STUD - STRAIGHT, RING LOCKED,
 CRES AMS 5731
 .375-16UNJC X .375-24UNJF

AS3322
 SHEET 1 OF 3

**REV.
C**

ISSUED 1979-09 REAFFIRMED 2001-11 REVISED 2006-09

FIGURE 1 - STUD

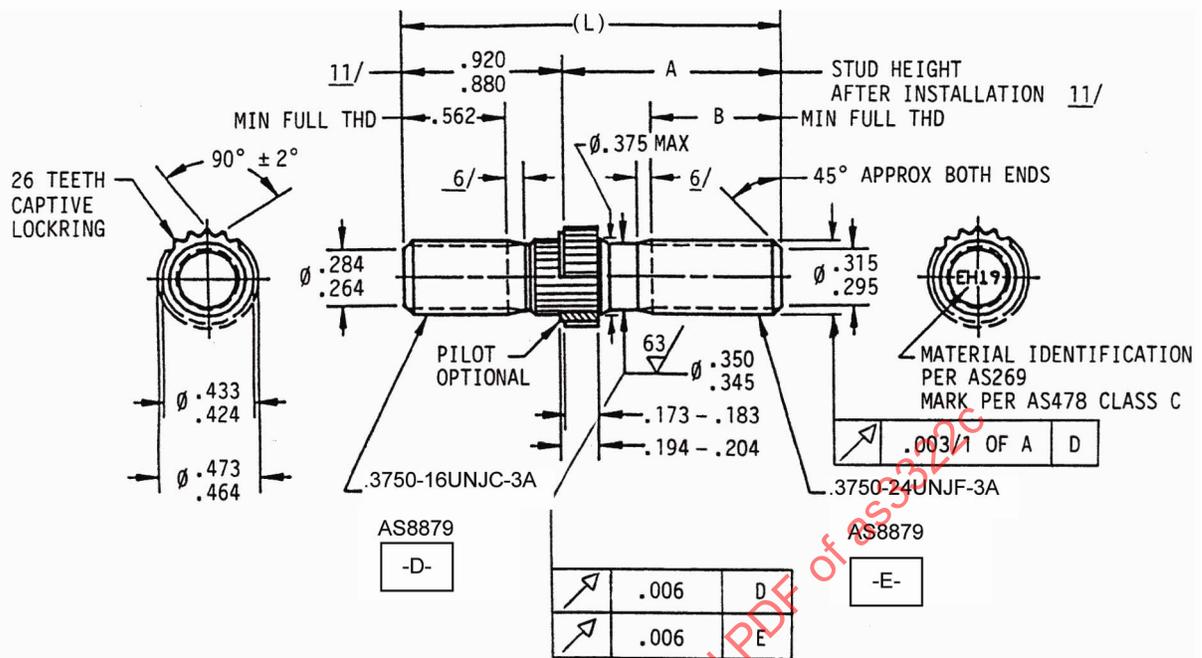
REVISE ROTATIONAL RESISTANCE VALUE.

- STUD SHALL PRODUCE A MINIMUM ROTATIONAL RESISTANCE VALUE OF 240 LBFxIN. TEST PROCEDURE PER NASM45909 AS APPLICABLE.
8. SURFACE TEXTURE: SYMBOLS PER ANSI Y14.36; REQUIREMENTS PER ASME B46.1. UNLESS OTHERWISE SPECIFIED, SURFACES TO BE 125 μ in Ra, EXCEPT SERRATIONS TO BE 250 μ in Ra, AND THREAD FLANKS AND ROOT TO BE 32 μ in Ra.
